Subject: Lake Tahoe Total Maximum Daily Load for Fine Sediment Particles, Nitrogen and Phosphorus

Final Lake Tahoe Total Maximum Daily Load

18 Appendix B – Responses to Peer Reviews

Figure 2-1. Location of the Lake Tahoe basin (USACE 2003).

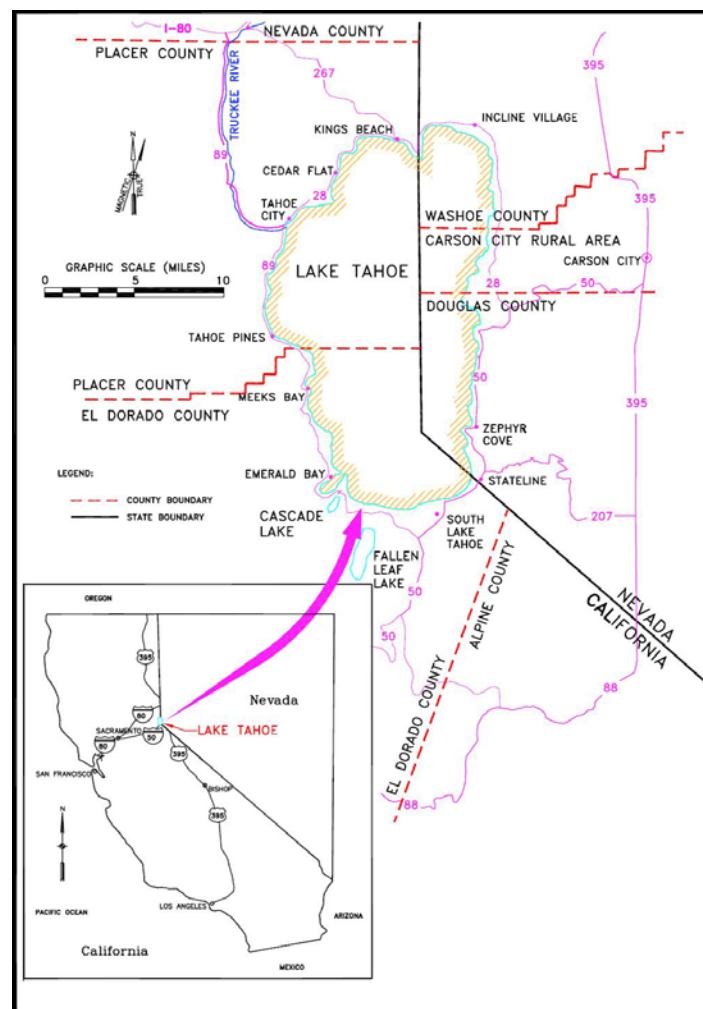
ES-2	4fb	It would be clearer if the values were given as percentages of the required reduction (e.g., $24.5 \times 100 / 32 = 76.5\%$ of the reduction should come from urban uplands.)
2-1		The map (Figure 2-1) is not very helpful. It is unclear where the line between CA and NV is. It is not clear that the unnamed area on the NW end of the lake is a part of

11-7	16fb	County is identified as Ormsby on Figure 2-1.		
	14	Appears to be some missing text at end of line.		
11-10		Most of the example load reductions are vague and not very helpful.		
12-8	¶ 2	What is this evidence? Merely citing a couple of references is not adequate here. The text should indicate the magnitude of the changes.		
	Last ¶	It would be useful to have some measure of variability for the deep mixing phenomenon. (4 ±X years). I suspect the record is long enough to provide a reasonable estimate of the variability in the frequency of deep mixing.		
13-4	¶ 1	This paragraph strikes me as indicating that a huge and unseemly amount of bureaucracy is associated with the management of Lake Tahoe.		
	¶ 2	It would be useful to say something about the way stormwater samples will be collected. Presumably (hopefully) they will represent event-integrated samples rather than grab samples. Note that "un-ionized" (line 4) should be hyphenated to avoid confusion with the word unionized.

PB-21: The location map, Figure 2-1 in the Final Report has been replaced with a more accurate figure.

Figure 3-2. Influence of particle size on light scattering (modified from Swift et al. 2006).

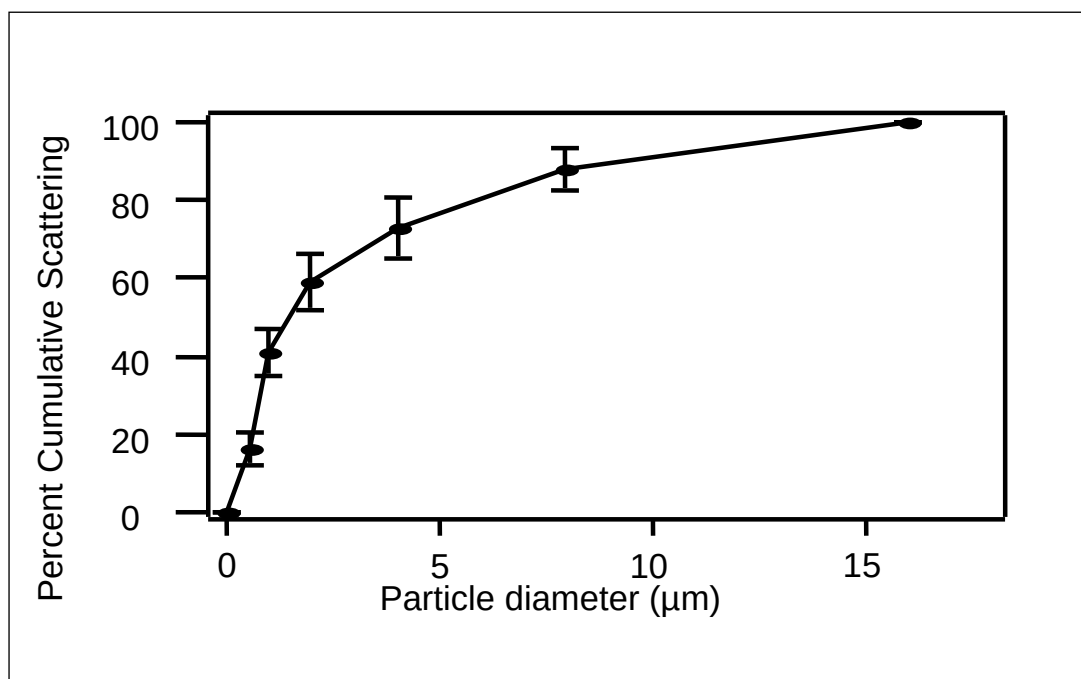
6. Figure 3.3 is difficult to interpret. What is the assumed abundance or mass per unit volume of particles upon which this graph is based? The graph is meaningless without a more complete explanation of the underlying assumptions or of the observations that are portrayed here.

What are the sizes of the particles represented in Figure 3-2?

WL-5: The text was modified to clarify this graph (Figure 3-2) in the Final Report in Sections 3.1 and 3.2 and in the Technical Report for Figure 3-8 in Section 3.4.1.

JM-21: The size of particles represented in Figure 3-2 of the Final Report (and Figure 3-8 of the Technical Report) were particles <16 µm in diameter. This information was added to the appropriate figure captions.

Figure 3-4. Annual average primary productivity in Lake Tahoe from approximately 25-30 measurements per year (UC Davis – TERC 2008).

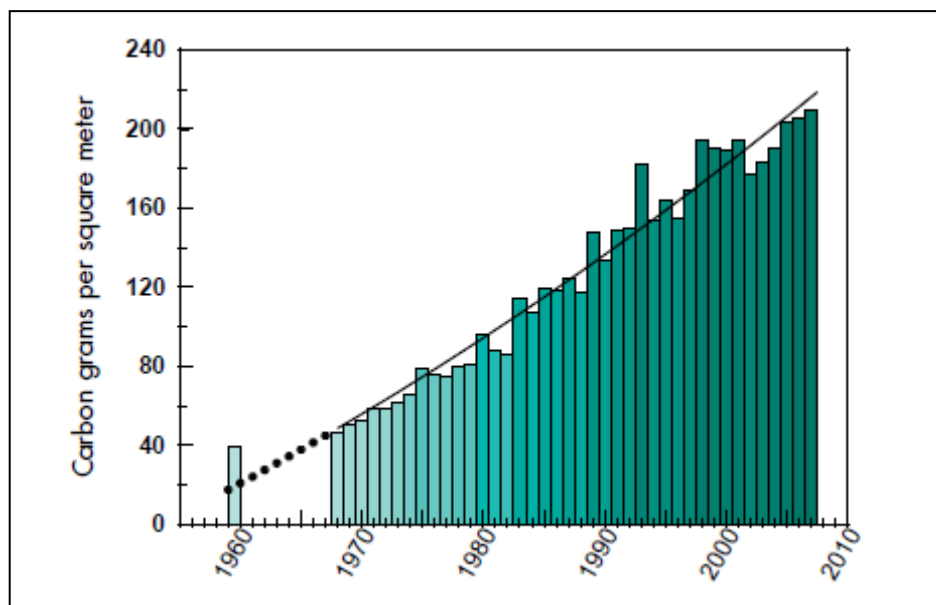
7. Figure 3-4 also cannot be easily interpreted based on the labels (see also TMDL technical report). The scattering effect of pure water is not labeled on the graph. Inorganic particles are labeled “sediment” although sediment is the name for all particles and not just inorganic particles. Organic particles are termed “algae” although it has already been stated that organic particles include other items.

WL-6: The figure and captions have been revised in both the Final Report (Figure 3-4) and Technical Report (Figure 3-11).

Figure 8-1. Conceptual Lake Clarity Model.

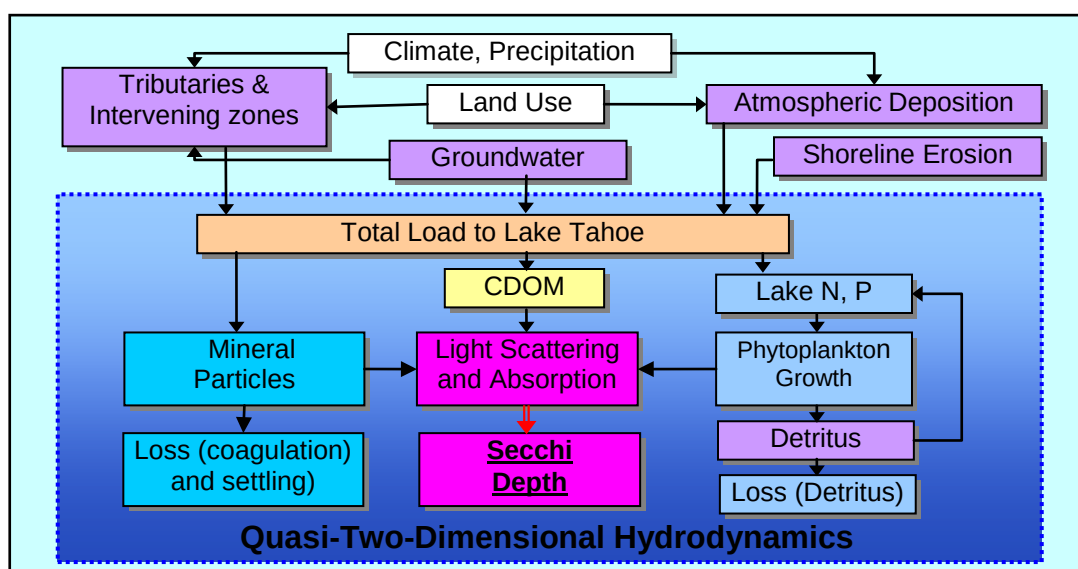
14. In Figure 8-1, the output of the upper part of the flow diagram is shown as total pollutant load. Actually, this load is more correctly referred to as total load. Only a portion of this total is traceable to pollution. We cannot count every ounce of phosphorus, nitrogen, or suspended solids as pollution. Also, in the same diagram, there is a reference to CDOM, which comes in from the watershed mostly. It is good to have this component in the model, but the means of estimating it is not given in the text, nor is any information given on the treatment of CDOM in the model.

WL-12: Not all nutrient and fine sediment loading to Lake Tahoe (and to other waterbodies) is a pollutant. The word ‘pollutant’ was removed from Figure 8-1 in the Final Report and Figure 6-1 in the Technical Report. The term ‘pollutant’ is used in the TMDL to include both the nutrient and sediment material because the TMDL allows for reduction of these materials regardless of its ultimate source (i.e. surface runoff can include both anthropogenic and natural sources) and treatment/control applies to the combined load. The CDOM (colored dissolved organic matter) term in the conceptual model (Figure 8-1 Final Report)) is supported by laboratory experiments using water from Lake Tahoe. The value used in the model for absorption due to CDOM is given in Table 6-4 in the Technical Report along with a reference.

Figure 8-2. Measured and modeled Secchi depths for 2000-2020. The close agreement during the period between 2000-2005 between field data and modeled output highlight utility of the Lake Clarity Model (Sahoo et al. 2009).

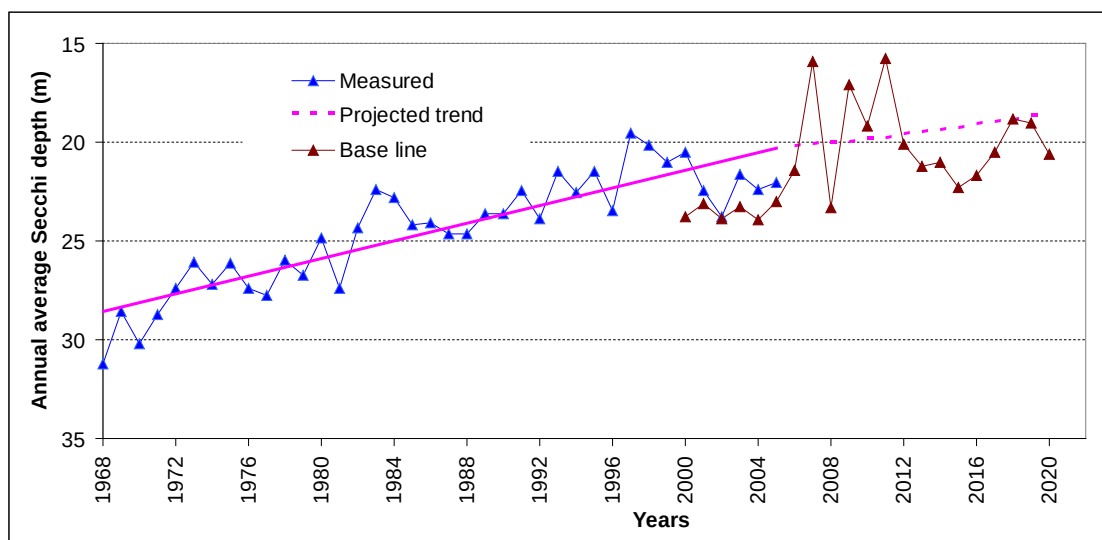
16. Figure 8.2 also poses some problems. Years 2000-2005 are reported to show good agreement, but there are some reasons to question this conclusion, as mentioned above. More troubling is the very wide variation of predicted secchi depths after 2005. The range of variation seen here for predictions is not found anywhere in the previous record of observed secchi depths. Certainly secchi depth observations must

Figure 13-1. Sampling locations for LTIMP Stream and Lake (TERC) sites (Tetra Tech unpublished). The Index Station is the TERC Monitoring Station that is near the west shore, it is located 2km from the shore and is positioned over deep water (greater than 100 meters deep).

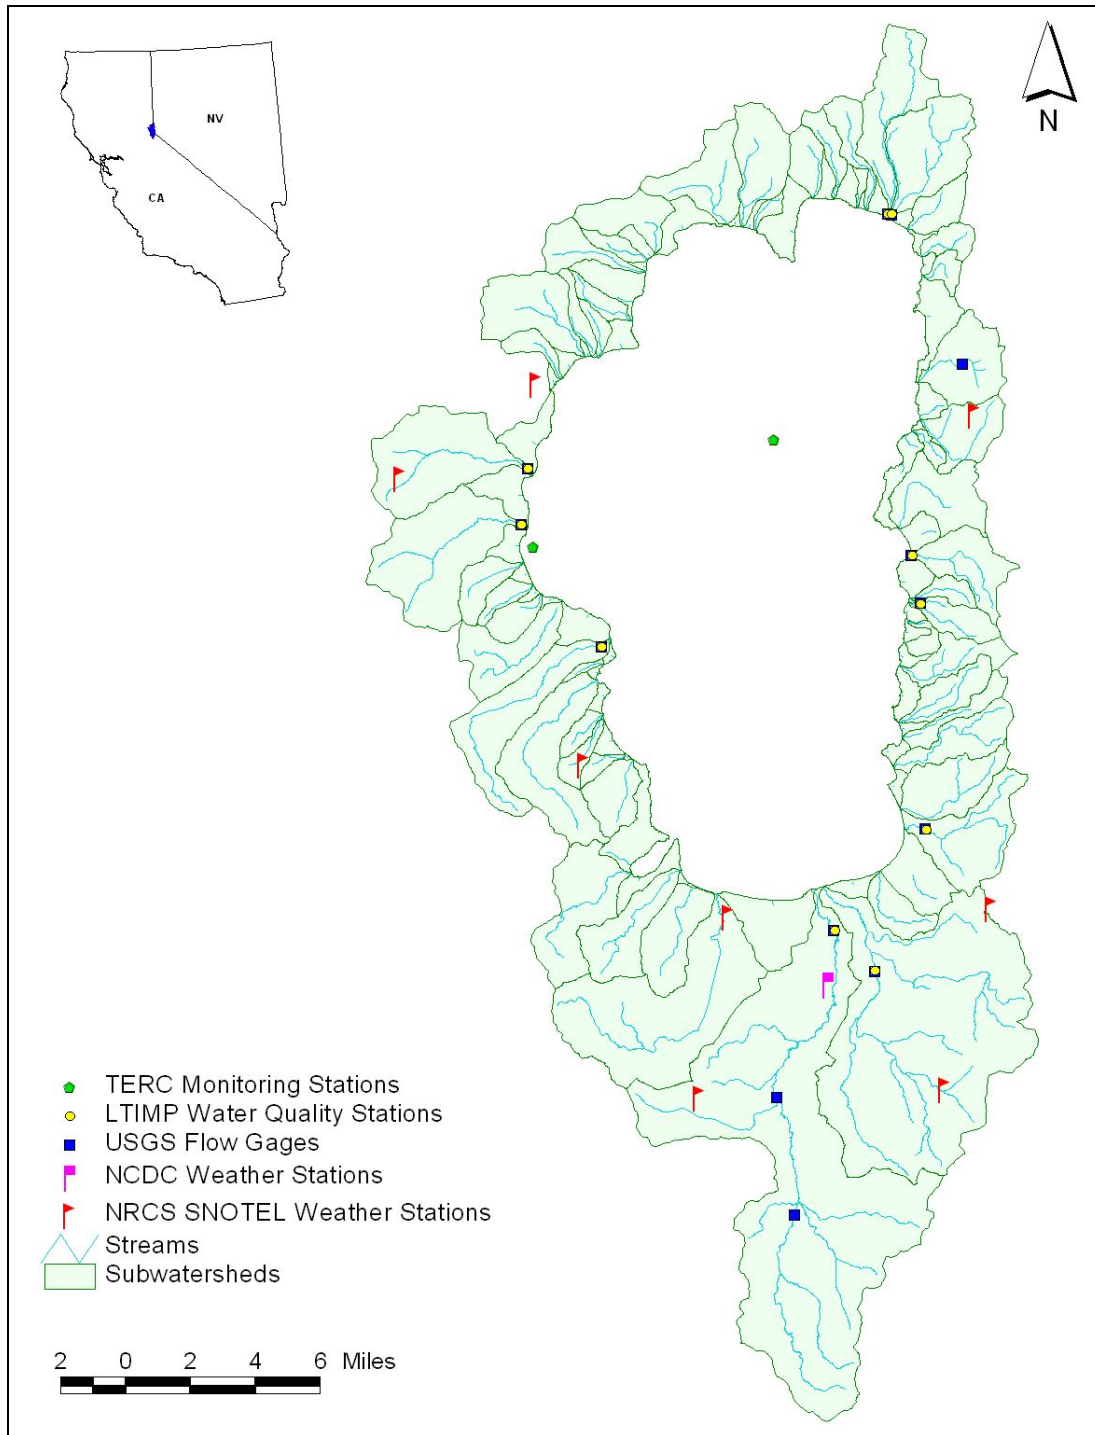
13-7	Last ¶	The text should say how far from shore the index station is. The map in Figure 13-1 shows the station as very close to the shore. Text elsewhere indicates the station is 2 km from shore. The figure may need to be corrected, and it would be useful to label each TERC station on the map.
14-2	1	It is not clear exactly what the \$10 million figure refers to.
14-3	¶ 1	It would be helpful if the text would provide some measure of the uncertainty remaining in the key models and the magnitude by which the uncertainty was decreased as a result of developing the site-specific models.
14-4	8fb	I think the authors mean “First, <i>conservative</i> assumptions were made....” It would help if this paragraph would indicate that examples of the conservative nature of the
